REPAIR PLAN FOR THE Z-AREA SALTSTONE VAULT 4, CELL A (U)

Design Change Form (DCF)

6. Area Z AREA		7. Project No. and Name U-PMT-Z-00098, Z AREA SALTSTONE VAULT #4 CELL A ROOF CRACK (U)		
8. Originator DAVID J. HUIZENGA		Date 3/18/98	9. Organization PE&CD SFSD	10. Address 705-K

DCF No.
C-DCF-Z-00040

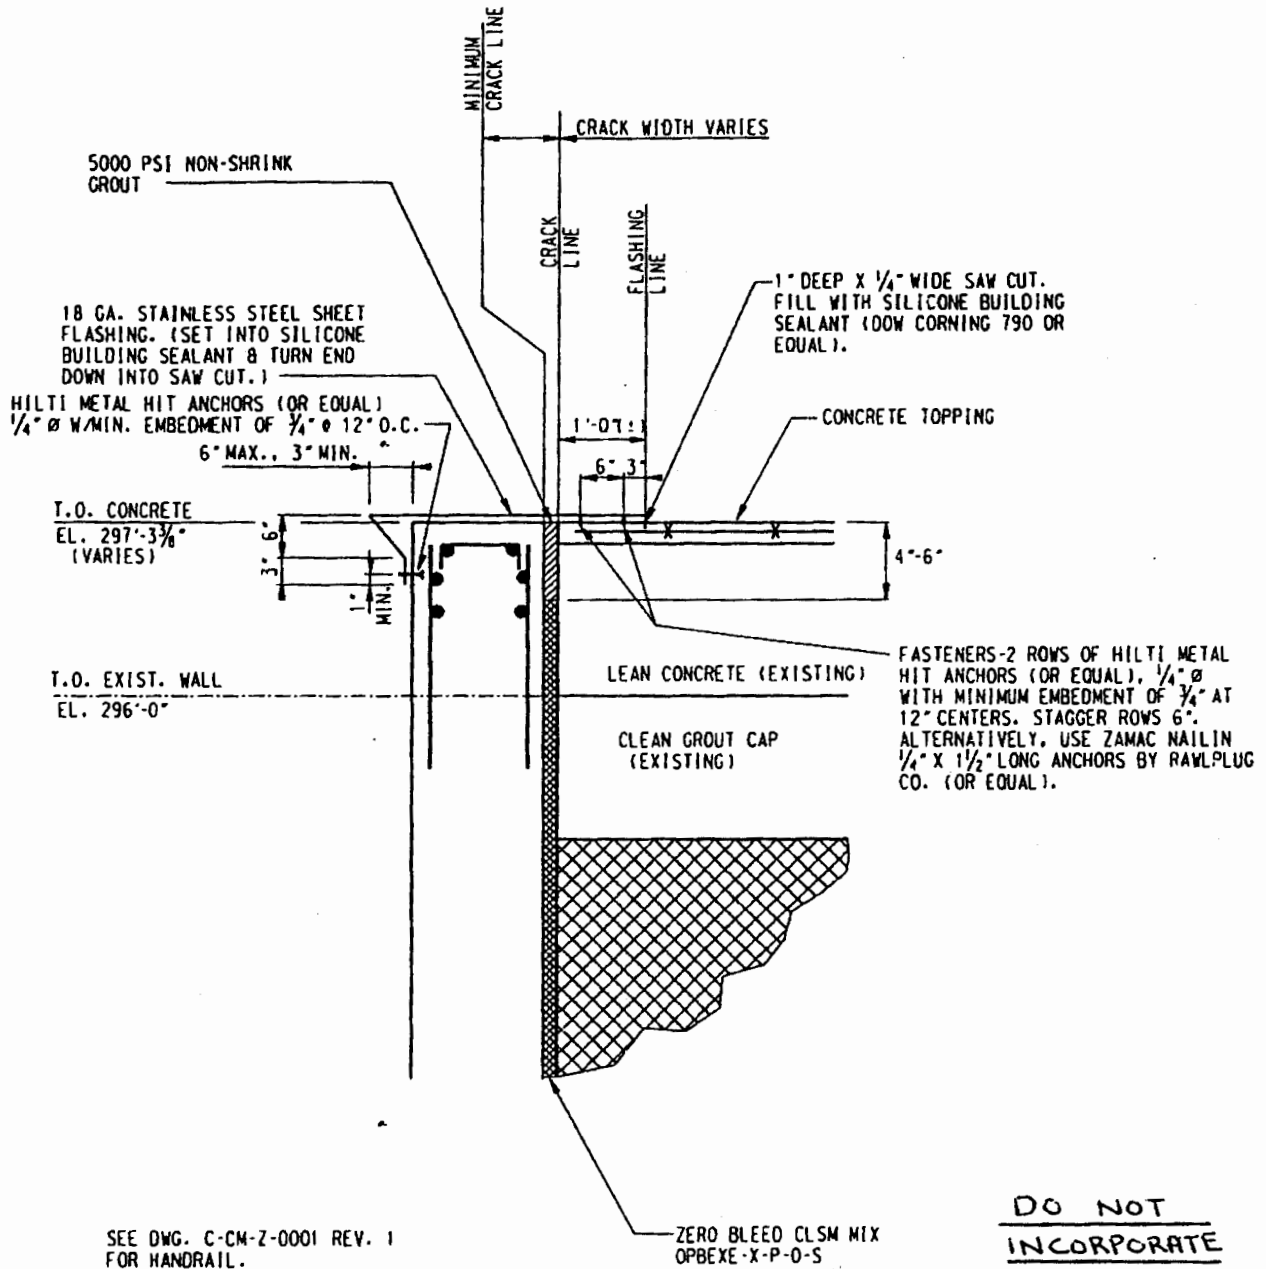
THE FLASHING SHALL WRAP OVER THE EDGE OF THE WEST WALL SIMILAR TO THE ATTACHED DETAIL AND BE SEALED WITH SILICONE BUILDING SEALANT (DOW CORNING 790 OR EQUAL) TO PREVENT WATER INTRUSION. THE FLASHING LOCATED 2'-0" PAST THE ROOF PEAK SHALL TERMINATE AND BE SEALED WITH WITH SILICONE BUILDING SEALANT (DOW CORNING 790 OR EQUAL) TO PREVENT WATER INTRUSION. ADDITIONAL FASTENERS SHALL BE USED AT THE FLASHING TERMINATION LOCATION. THE ADDITIONAL FASTENERS SHALL BE 6" MAXIMUM CENTER-TO-CENTER AND 2" FROM THE EDGE OF THE FLASHING PLACED INTO THE CONCRETE ROOF AND THE NORTH WALL AND WEST WALL OF THE VAULT. FLASHING SEAMS SHALL OVERLAP 2" MINIMUM AND BE SEALED WITH SILICONE BUILDING SEALANT (DOW CORNING 790 OR EQUAL) TO PREVENT WATER INTRUSION.

THE FLASHING LINE IS DEFINED AS A LINE PERPENDICULAR TO THE WEST WALL OF THE VAULT LOCATED 1'-0" FROM THE SOUTHERN MOST CRACK LOCATION OR CRACK LINE. THE FLASHING LINE IS FROM THE WEST WALL OF THE VAULT TO A LOCATION 2'-0" PAST THE ROOF PEAK OF THE VAULT.

THE CRACK LINE AND THE MINIMUM CRACK LINE ARE DEFINED AS THE TWO (2) EDGES OF THE CRACK ALONG THE NORTH WALL OF THE VAULT. THE CRACK LOCATION AND WIDTH ALONG THE NORTH WALL OF THE VAULT VARIES. THE CRACK LINE IS THE SOUTHERN MOST EDGE OF THE CRACK ALONG THE NORTH WALL OF THE VAULT.

7. THE HANDRAIL SHALL BE RE-INSTALLED AFTER INSTALLATION OF THE FLASHING. EACH BASEPLATE OF THE HANDRAIL SHALL BE SEALED WITH SILICONE BUILDING SEALANT (DOW CORNING 790 OR EQUAL). THE SLOTTED HOLES IN THE FLASHING BELOW THE HANDRAIL BASEPLATES SHALL BE SEALED WITH SILICONE BUILDING SEALANT (DOW CORNING 790 OR EQUAL). HANDRAIL ANCHOR BOLTS SHALL BE RE-TORQUED TO THE MANUFACTURER'S REQUIREMENTS.
